**City of Portland, Maine - Building or Use Permit Application** 389 Congress Street, 04101, Tel: (207) 874-8703, FAX: 874-8710

**AMENDED PERMIT APPLICATION**

LAND USE - ZONING REPORT

BUILDING PERMIT REPORT

LOT 25 Pines @ Wyoming  
 Plot Plan Prepared by Greg McCormack

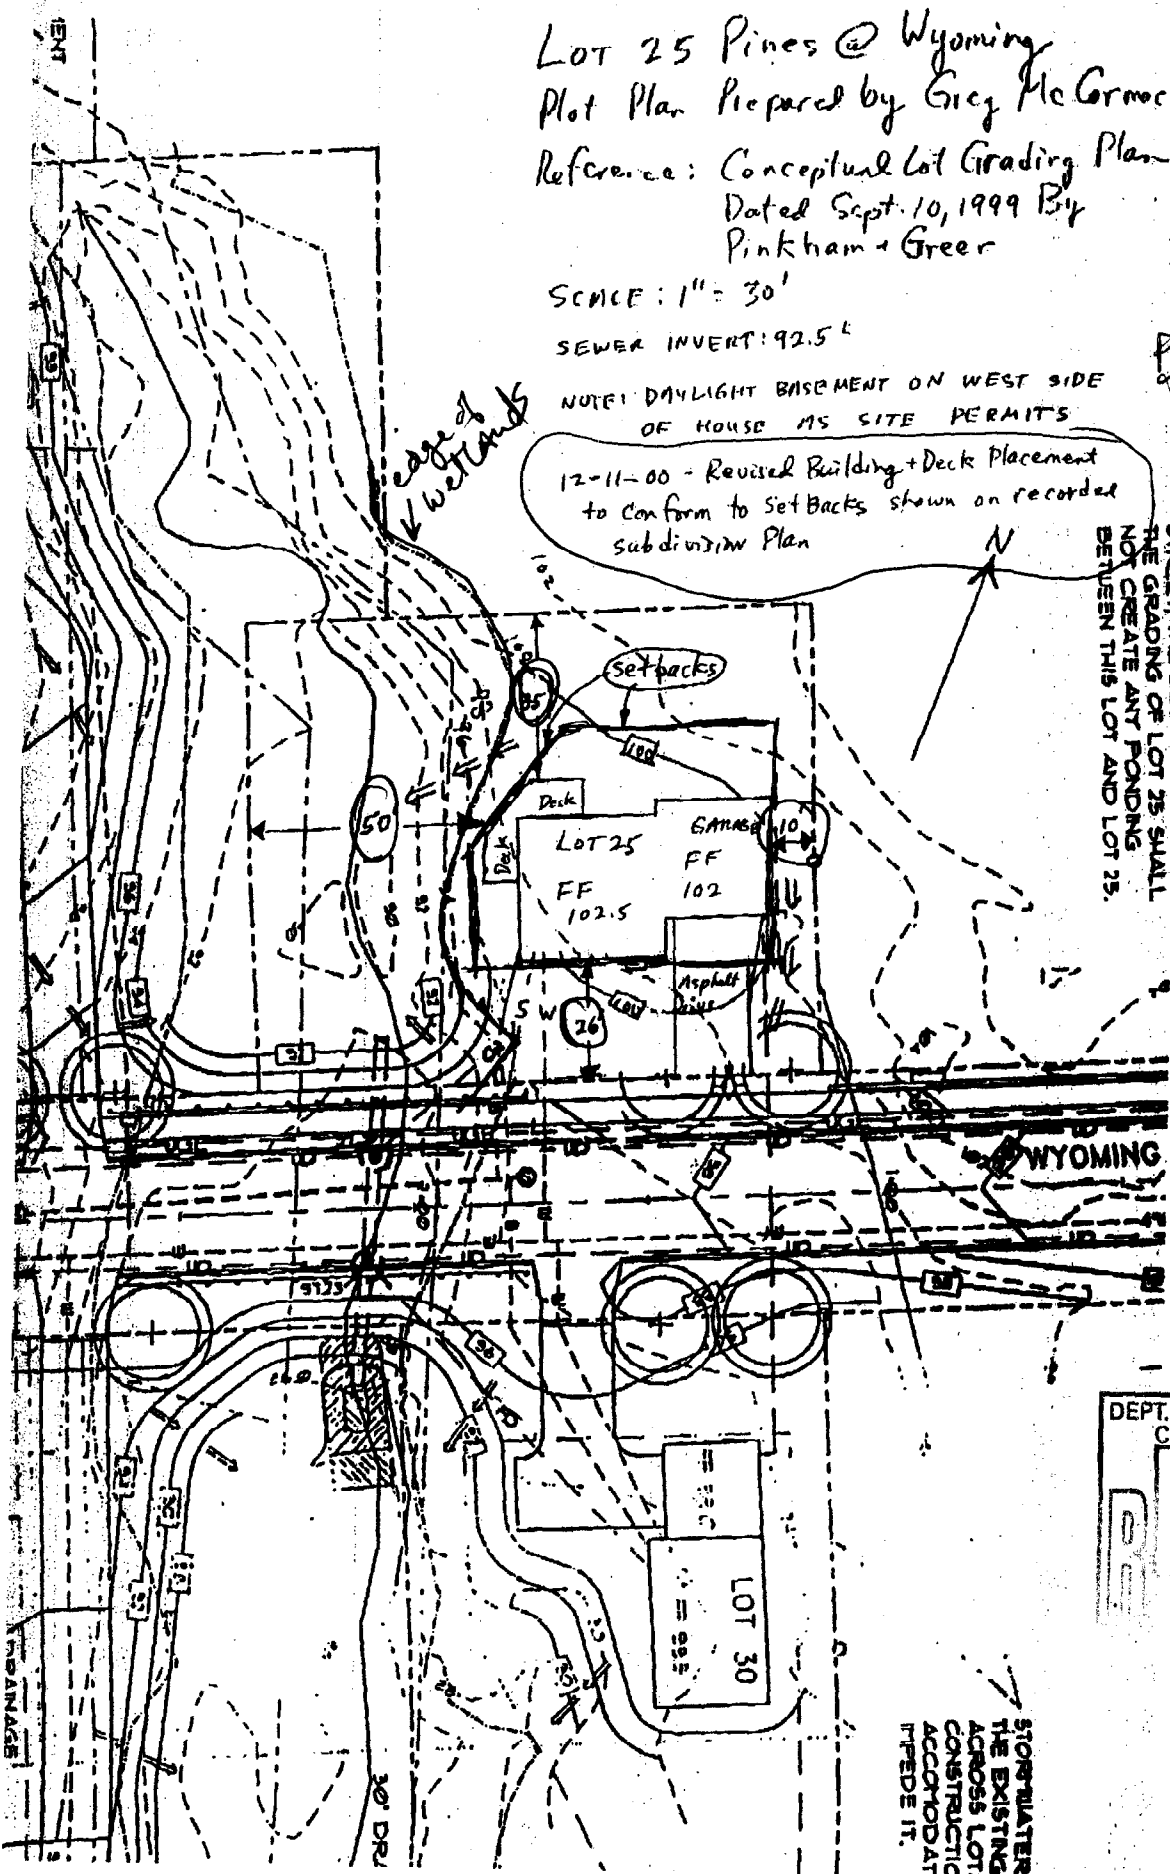
Side Yard - 14' req - may reduce one side to no less than 8' if for every 1' taken off, 1' shall be added to other side - 10' is 50' shown

revised to meet slope deck is outside envelope - need revised plans received 12/11/00

min. Basement elevation per recorded site plan = 93.5' #10 House locations to be within building envelopes shown on section plans

12-11-00 - Revised Building + Deck Placement  
 to conform to Setbacks shown on recorded  
 subdivision Plan

B' SECTION

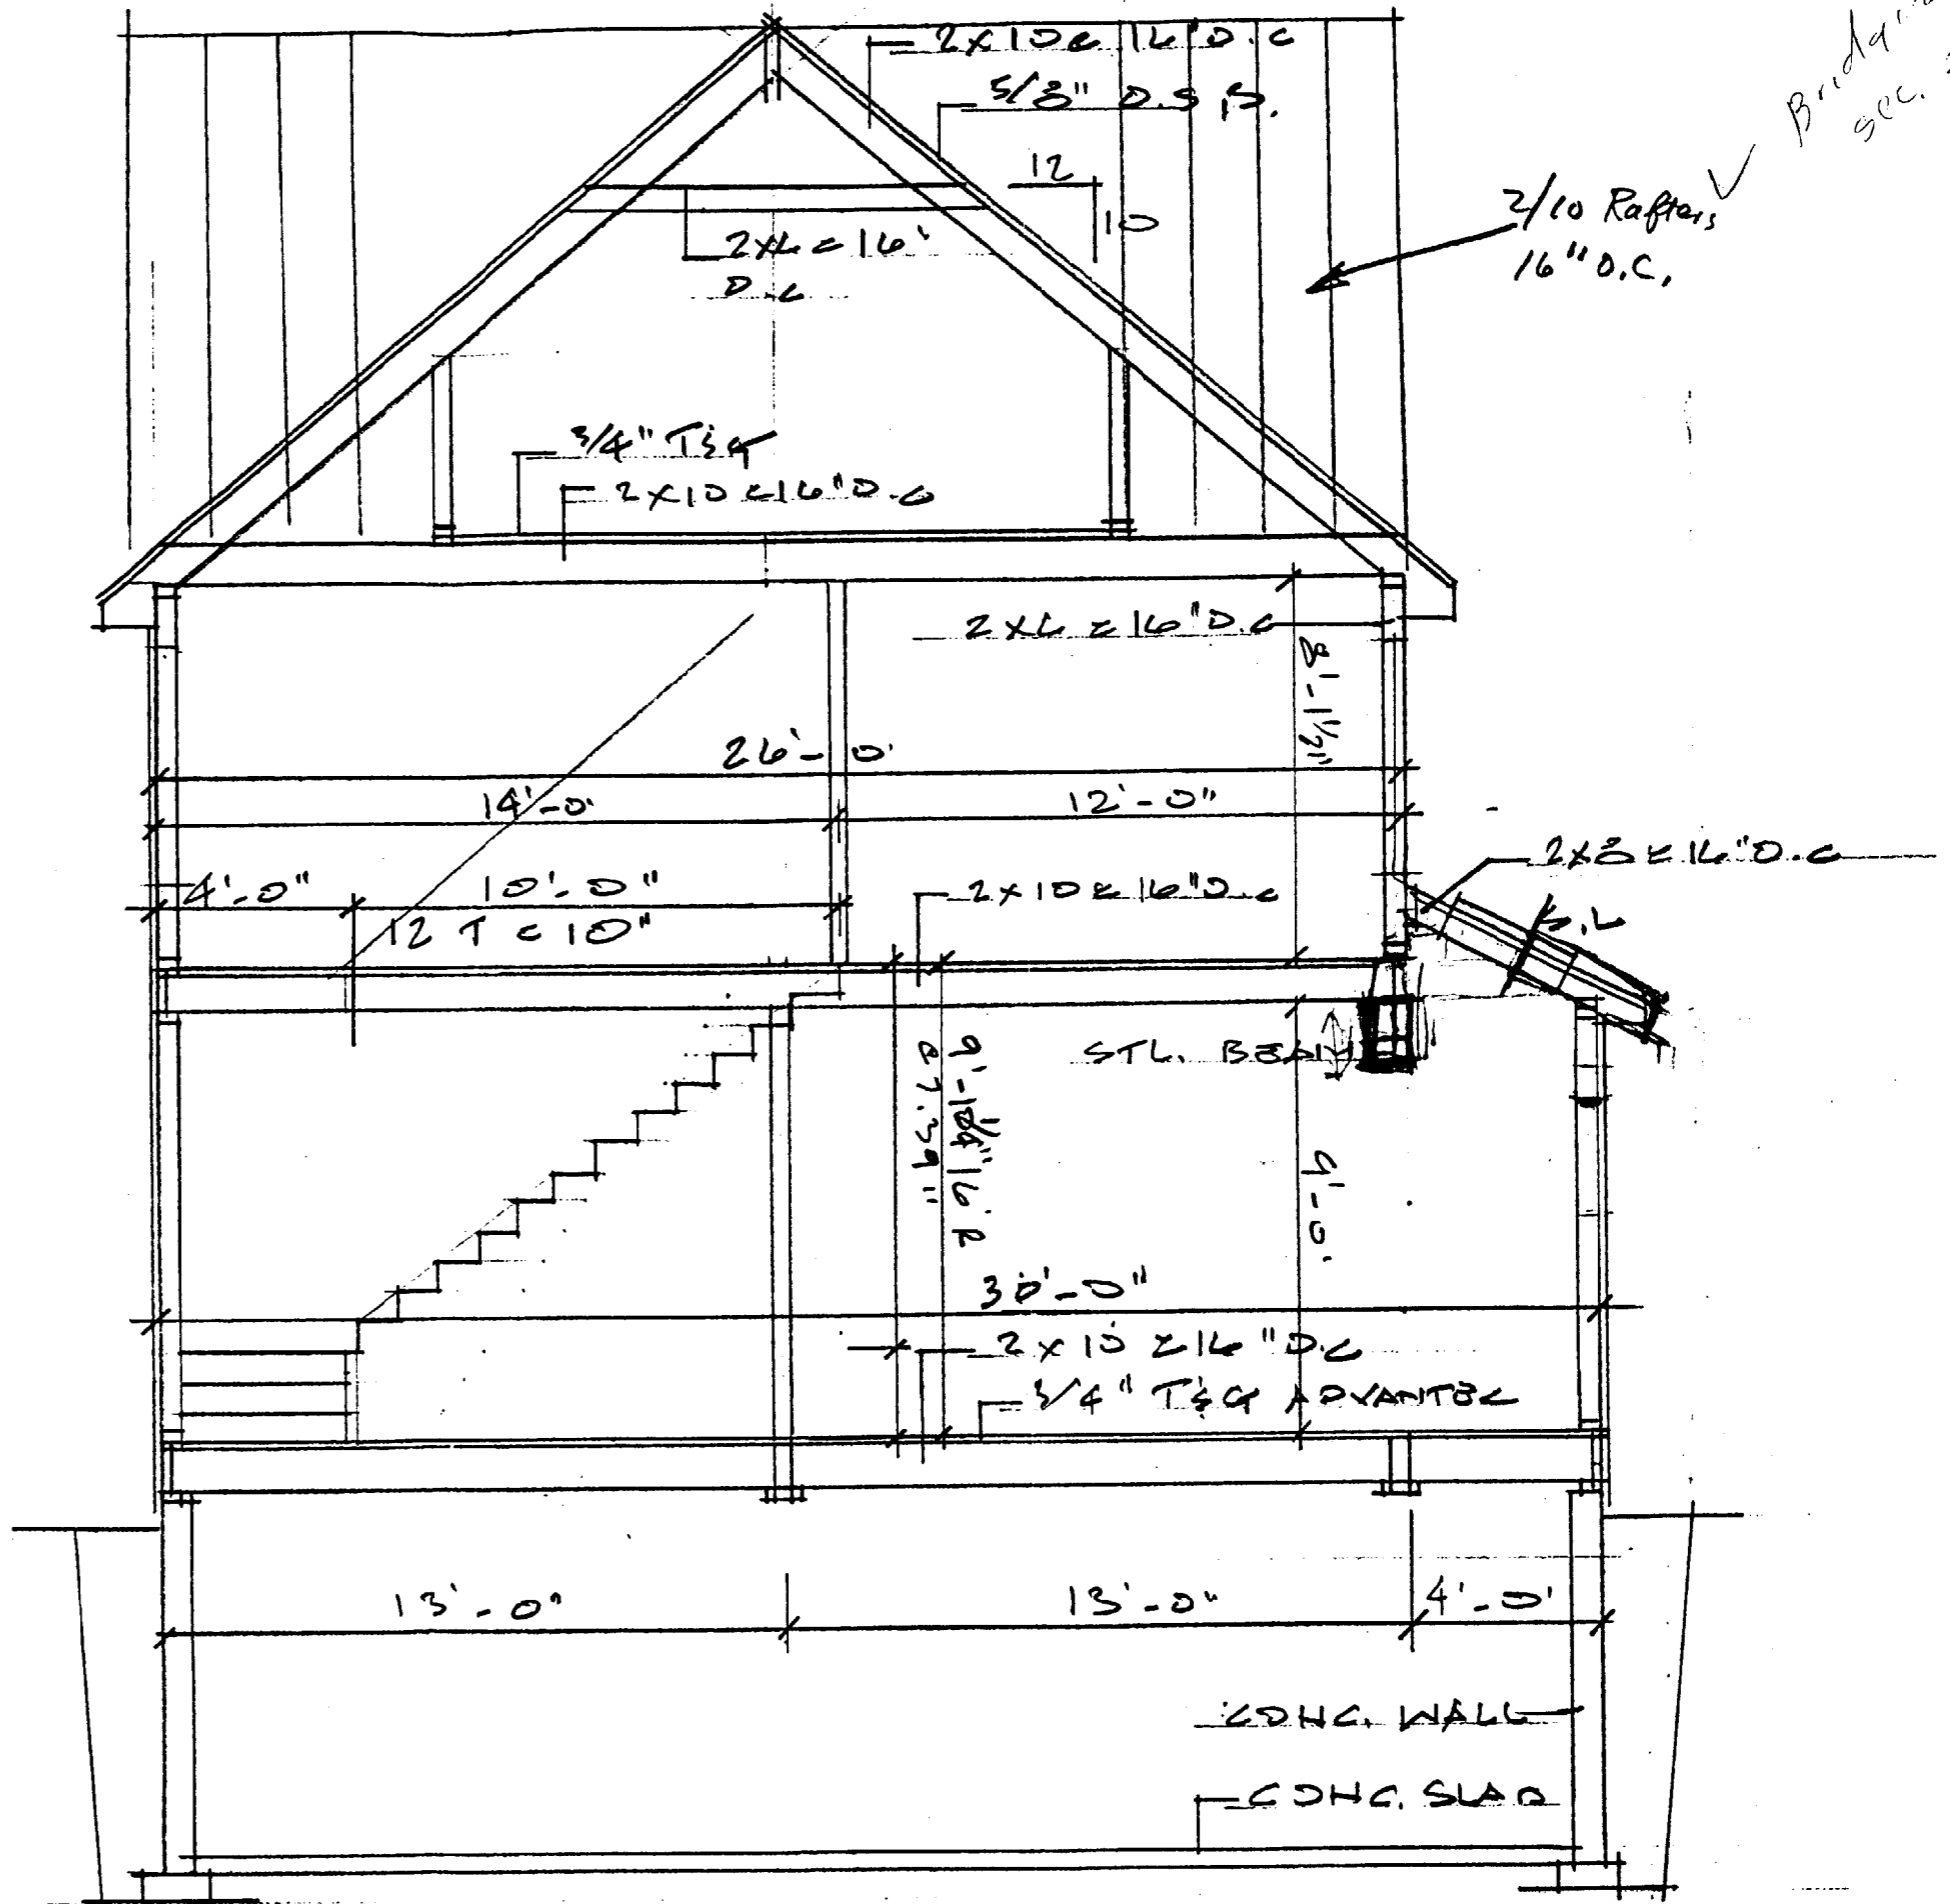
Bridging  
sec. 23 @ 5.16
